# Recent Technical Contributions to MSQS-2

T11/13-050v0

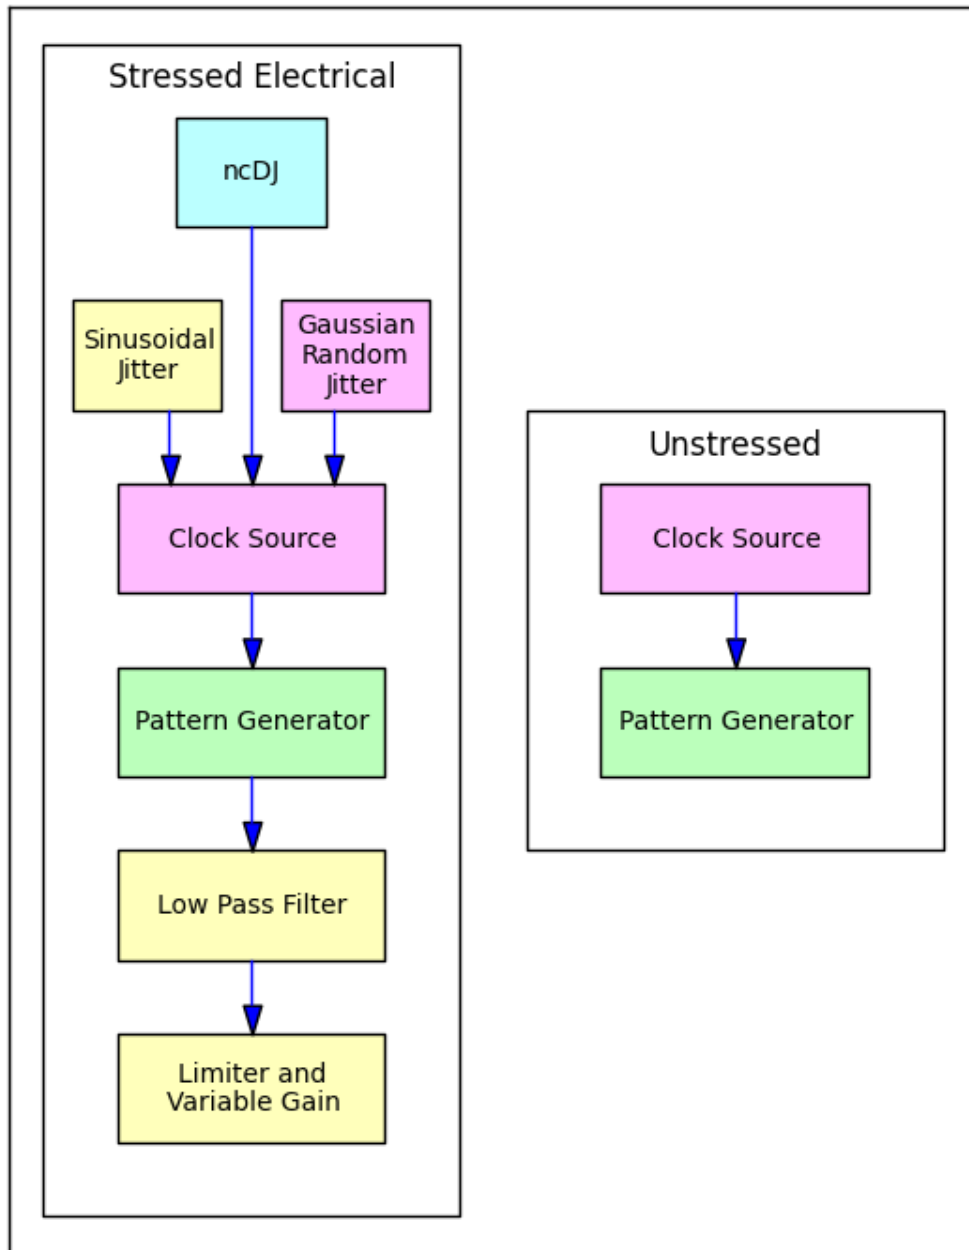
**Problem:** Figure 3.9 on electrical stress pattern generator did not include the “Uncorrelated Bounded High Probability Jitter” stressor. Proposed solution is shown on page 2.

This leads to the following figure:

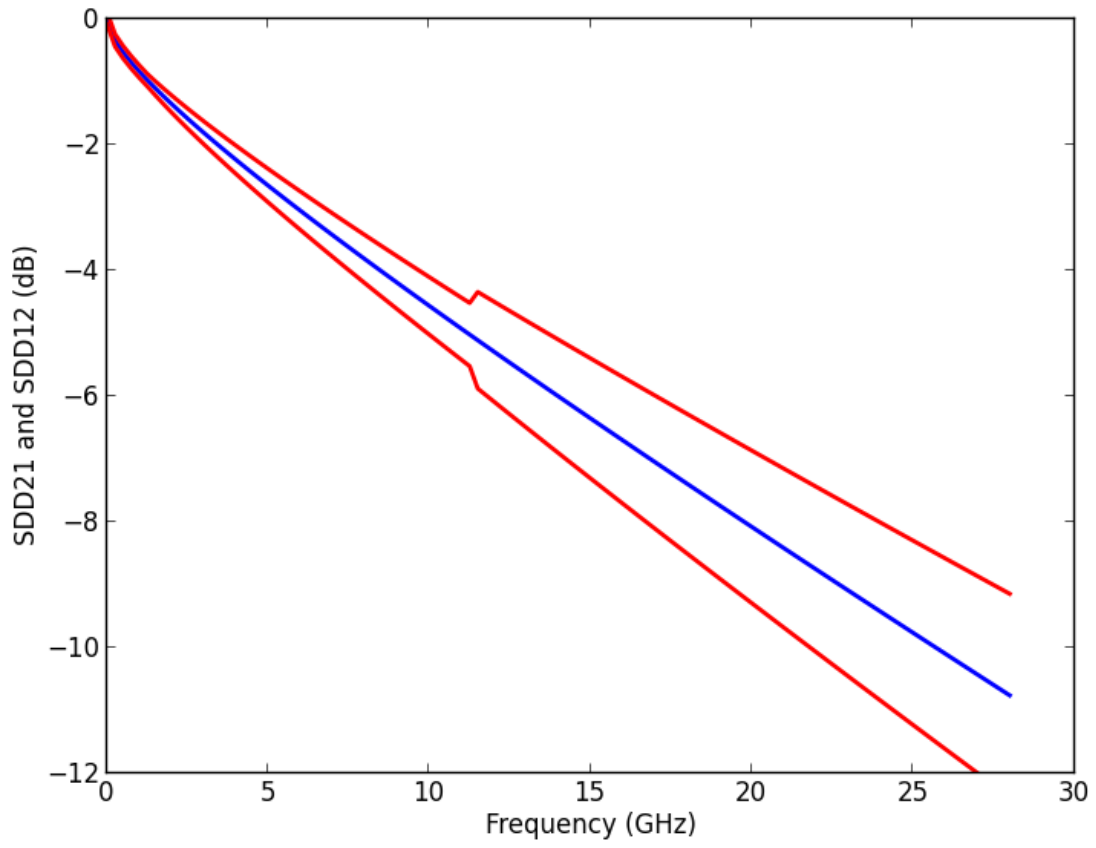
**Problem:** the “Frequency dependent attenuation” subclause 3.2.10 is empty. Mike Dudek proposes the following text:

**The 6dB loss at Nyquist that this generates plus the 1.25dB loss of the MCB host trace is approximately equal to the 7.3dB Host PCB loss of the OIF VSR spec on the assumption that the module electrical receiver for 32GFC will be similar to that of OIF VSR. This assumes that the extra host loss required for the 32GFC application will be compensated by the Tx FIR filter that is not required for the OIF VSR spec.**

The Frequency dependent attenuation shown in Figure 3.4 in combination with the stressed pattern generator and MCB is intended to provide a similar waveform to that produced by a worst case host. The Frequency dependent attenuation should therefore have similar characteristics to a host PCB trace. As the stressed pattern generator does not have a Transmitter FIR filter whereas the host ASIC is expected to do so the loss of the Frequency dependent attenuation plus MCB trace loss cannot be as great as the worst case host. The frequency dependent attenuation should have a target loss characteristic of

$$SDD21(\text{dB}) = 6.0 \cdot (0.001 - 0.096 \cdot \sqrt{f} - 0.046 \cdot f)$$

In which f is the frequency in gigahertz for  $50\text{MHz} < f < 28\text{GHz}$ . From 0.05GHz to 11.1GHz the discrepancy between the measured through loss and the target loss characteristic shall be within  $\pm 10\%$  in dB or  $\pm 0.1\text{dB}$  whichever is larger. For frequencies above 11.1 GHz and up to 28GHz the discrepancy between the measured through loss and the target loss characteristic shall be within  $\pm 15\%$  in dB.
